Document Version History

WD-1003-01 First released version.

WD-1003-02 Corrected document name WD-1001-04 to WD-1003-02.

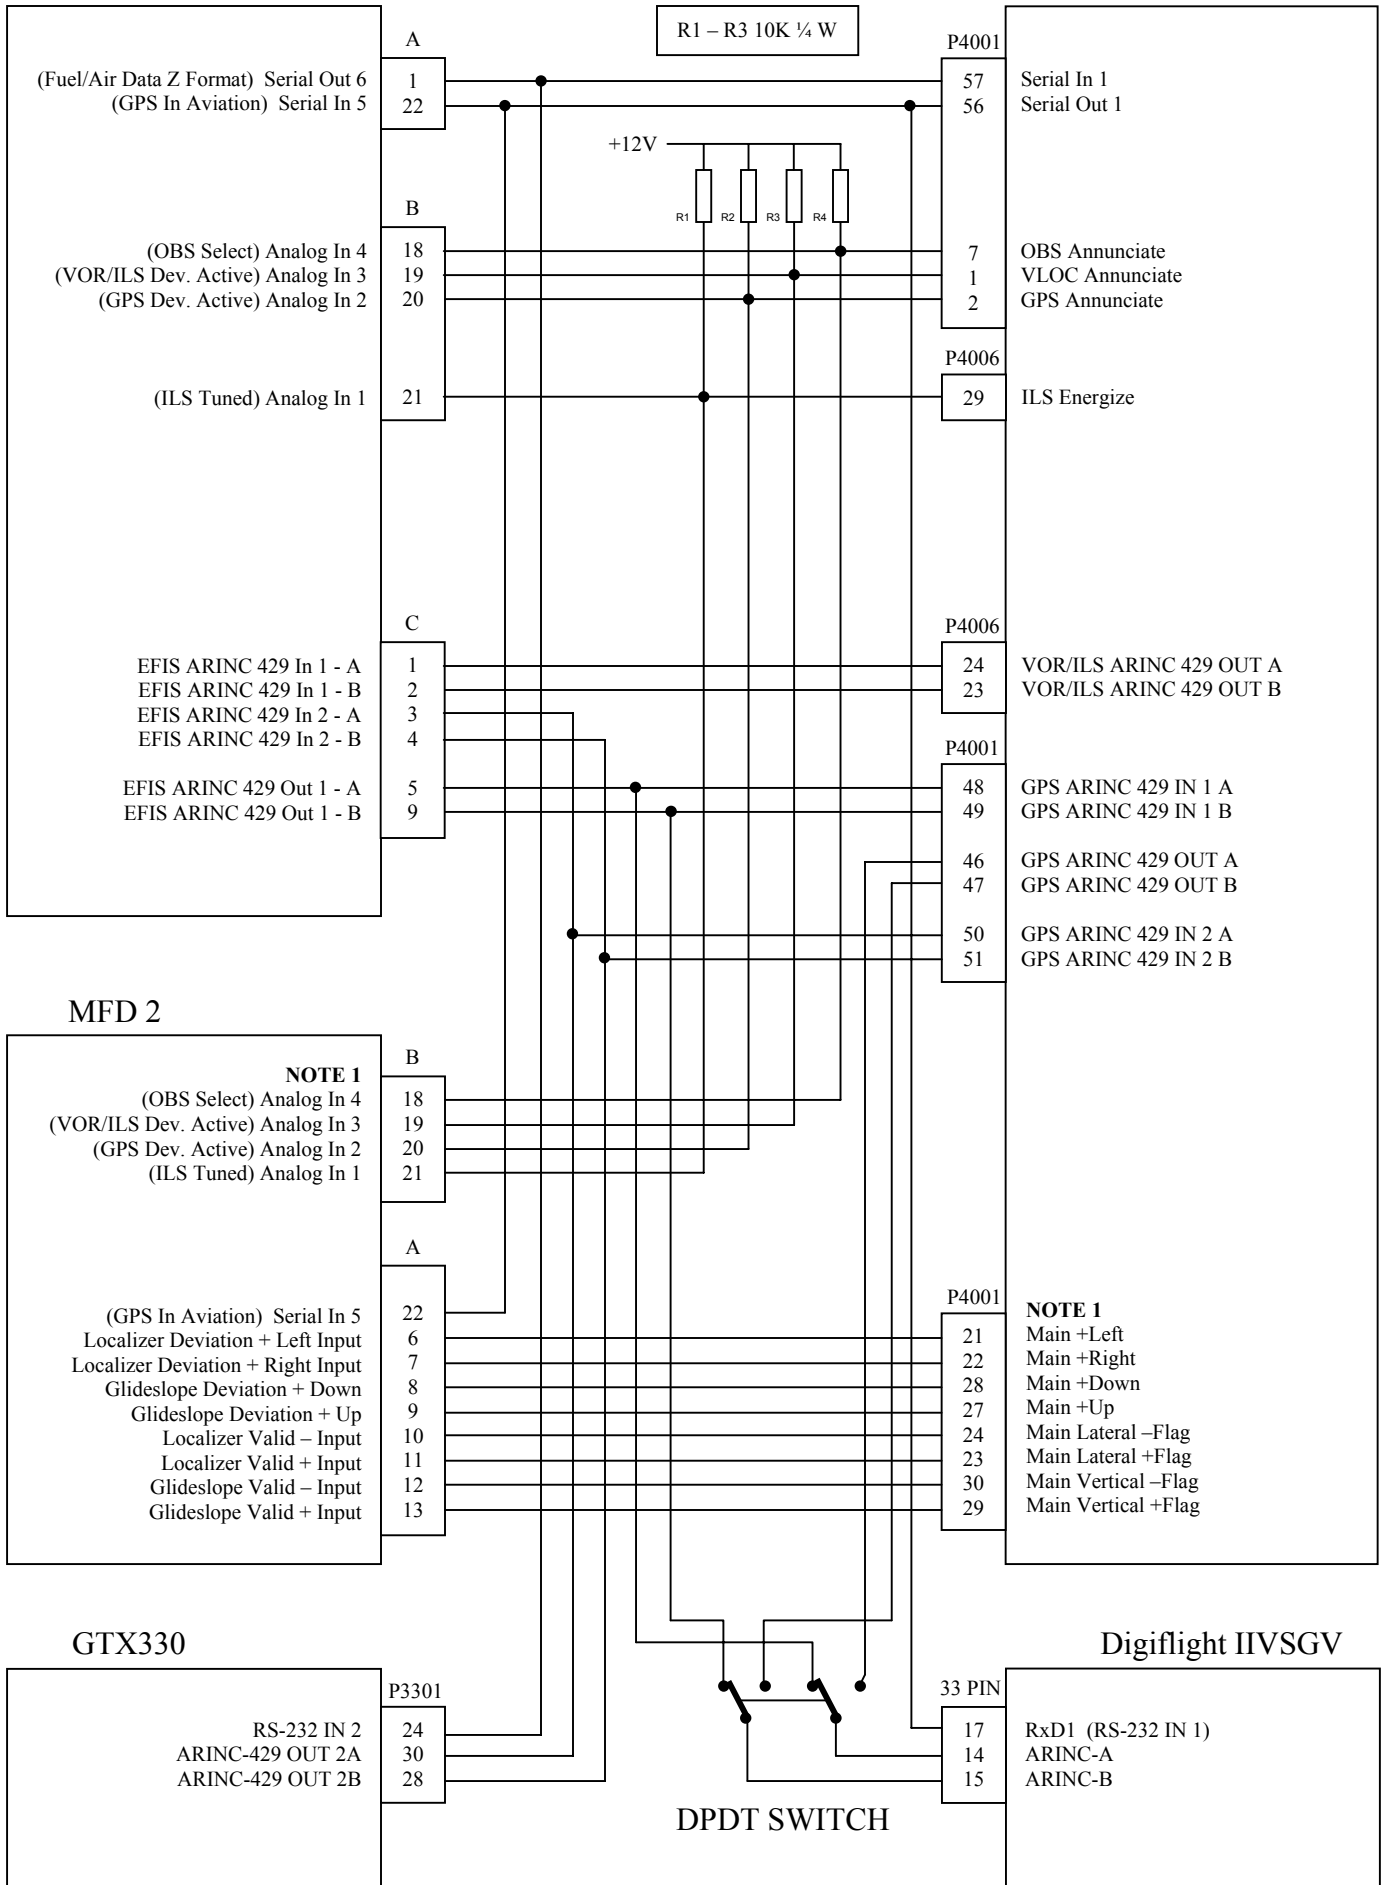
Removed MFD-2 PIN A-20 from MFD-1 C-5.

The ARINC-429 connection between the GTX330 and GNS430 is now shown for clarification.
